2020/2816/P – 9 Lyndhurst Terrace, NW3 5QA

Delegated Report		Analysis sheet	Expiry Date:	19/08/2020
(Members Briefing)		N/A	Consultation Expiry Date:	
Officer			Application Number(s)	
Kristina Smith			2020/2816/P	
Application Address			Drawing Numbers	
9 Lyndhurst Terrace London NW3 5QA			Refer to Draft Decision Notice	
PO 3/4	Area Team Signature	C&UD	Authorised Officer Signature	
Proposal				
Demolition of existing dwelling and replacement with a three storey (plus basement) single dwelling house with terraces to front and rear and associated landscaping works				
Recommendation(s):	Grant Conditional Planning Permission Subject to a Section 106 Legal Agreement			
Application Type:	Full Planning Permission

Proposal:
Demolition of existing dwelling and replacement with a three storey (plus basement) single dwelling house with terraces to front and rear and associated landscaping works

Windows on flank elevation of no.7

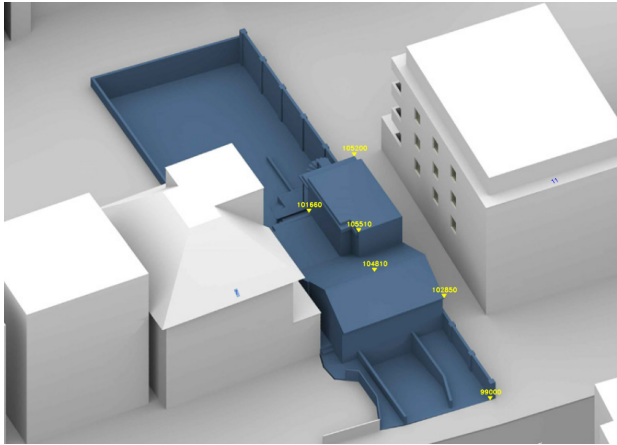
- 2.24 The daylight assessment did not provide data relating to the windows at this property as there are no habitable rooms that would be affected. Officers have reviewed floorplans and confirm this to be the case with the windows serving bathrooms, a kitchen and stairwells. The first floor flat benefits from unobstructed daylight and outlook to the east and west whilst the 2-bed flat to the rear of the second floor would continue to receive daylight and outlook to the west and south above the lower building adjacent at no.5. At roof level, the north facing dormer window serves a bedroom; however, this would not be impacted by the development which would sit lower. Furthermore, the dormer has dual aspect. As such, the rooms are not considered sensitive to a loss of daylight or outlook.

- 2.25 The south facing windows that serve the stairwell will be obscure glazed and secured by condition to prevent any views into windows on the north elevation of no.7.

- 13 The first and second floor windows serving the stairs on the south elevation of the development hereby approved shall be obscure glazed and fixed shut. The windows shall not thereafter be altered in any way.

Windows on flank elevation of no.11

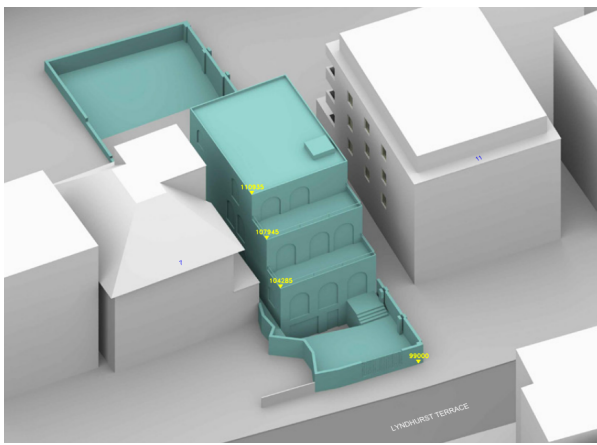
- 2.28 Based on the below diagram, the three columns of windows in the south flank elevation are understood to serve, from left to right: living room (dual aspect), bedroom, bathroom (obscure glazed).

- 2.29 The additional height would have a noticeable impact on several windows on the flank south facing windows of no.11, as demonstrated by the daylight and sunlight assessment. Given that

the living room windows are also served by a primary west-facing window and the bathroom windows are non-habitable and obscure glazed, the impact on these two columns of windows are less important than the impact on the middle column of windows which serve bedrooms.

2.30 The impact on the bedroom windows at first and second floors would not comply with BRE guidance. At first floor level, the proposal would result in a 65.66% loss of VSC, reducing it to a retained level of 9.46 whilst at second floor level, the proposal would result in a 52.35% loss, reducing it to a retained level of 16.03. In practice, more flexibility is usually afforded to VSC in an urban environment and a retained VSC of over 15 is generally considered to be acceptable which means that the only window to experience a loss beyond what is often tolerated is the first floor bedroom window. In this scenario, the impact is considered acceptable on balance for the following reasons. The first reason is to do with the site arrangement. At a height of lower ground floor plus one storey, the existing building is unusually low for its plot and as a result, the side elevation windows obtain more light from across the site boundary than would be the case in a typical street arrangement with a more consistent rhythm to the height of buildings. It is therefore not considered reasonable that the presence of flank windows at no.11 should prohibit additional height at no.9 so as to increase it to a similar height to that of its neighbours. It is worth noting that the proposed height would have to reduce considerably – probably by a storey – which would diminish the benefits the new building offers the site in townscape terms. Secondly, the window serves a secondary, rather than primary, bedroom of the flat. This is not to say the impact is unimportant but second bedrooms tend to be used more flexibly (if not at present then potentially in the future), for instance as a guest / spare room or study. The unit would continue to benefit from a well-lit, dual aspect living room and a main bedroom that is unaffected by the proposal.

2.31 In terms of privacy, the proposed building would bring second floor terraces in close proximity to the existing bathroom windows on the flank wall of no.11. Whilst the bathroom windows are obscure glazed already, there could well be a perceived sense of overlooking and so to mitigate this the applicant has agreed to a permanent planter on the second floor terrace that would prevent users from reaching the edge of the terrace. This would be retained in perpetuity.

- 6 The use of the second floor roof terrace shall not commence until the planter, as shown on the approved drawings (ref: 474_L12_03_A), has been installed. The planter shall be permanently retained thereafter.
